Subject: Responses to Additional Information Request on Revised Request to Amend License SNM-42, Chapter 5, *Nuclear Criticality Safety*

**Summary of NRC Requests for Additional Information (RAI) with BWXT  
NOG-L Responses for Amendment Request for Chapter 5 of the SNM-42  
License Application**

**BWXT Amendment Request  
Changes to Chapter 5, "Nuclear Criticality Safety"**

**Figure 1: Sketch of Models to Assess Top Reflection**

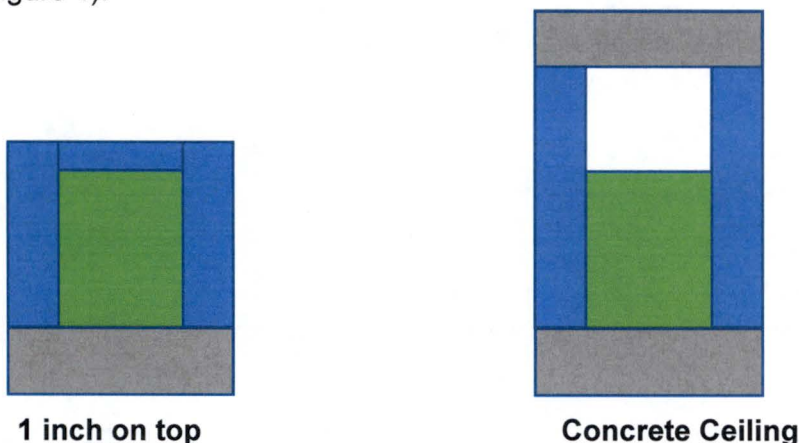
- (3) The fourth paragraph of LA Section 5.2.2.4 contains the following: "If there is a concrete roof over the fuel, the more reactive of a 1 inch thick water slab or the concrete at its actual height and using its actual thickness shall be used. (In the case of the concrete ceiling, the water box will extend to the ceiling.) These two sentences appear to contradict each other in regard to the thickness of the water box to be modeled. Clarify what boundary conditions will be applied when there is a concrete roof over the units being modeled.

- (3) Extending the water box means the lateral sides. To assess the concrete ceiling, the water box would be modeled with the 12 inches on the side and 1 inch directly on top. The model would then have the 1 inch water on top removed; the sides of the water box would be extended up to the concrete ceiling and the ceiling model with its actual thickness (see Figure 1).
